# Technical Service Bulletin

Subject:  
**HV battery warning lamp or message ON**

Models:  
PRIUS  
Model codes:  
ZVW30

G-0081T-1012

Figure 3

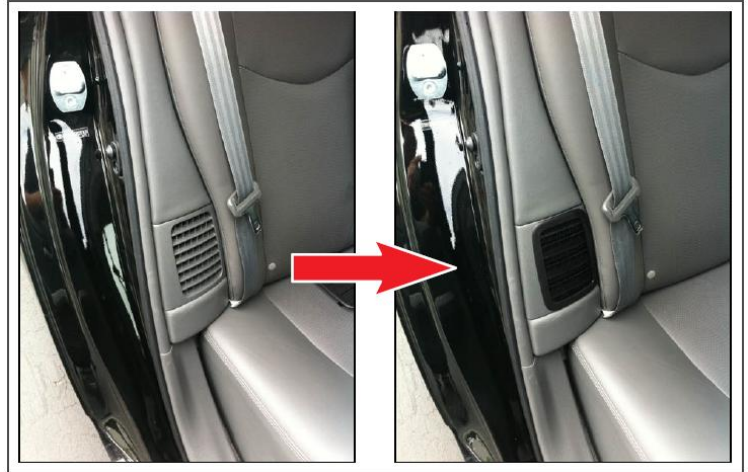
3. Replace the "Battery Assy, HV supply" according to repair manual.
4. Install the "Blower Assy, battery cooling" according to repair manual.
5. Install the "Filter, HV battery intake, no. 1" on top of air duct from "back Assy, rear side seat, RH" as shown in Figure 3.
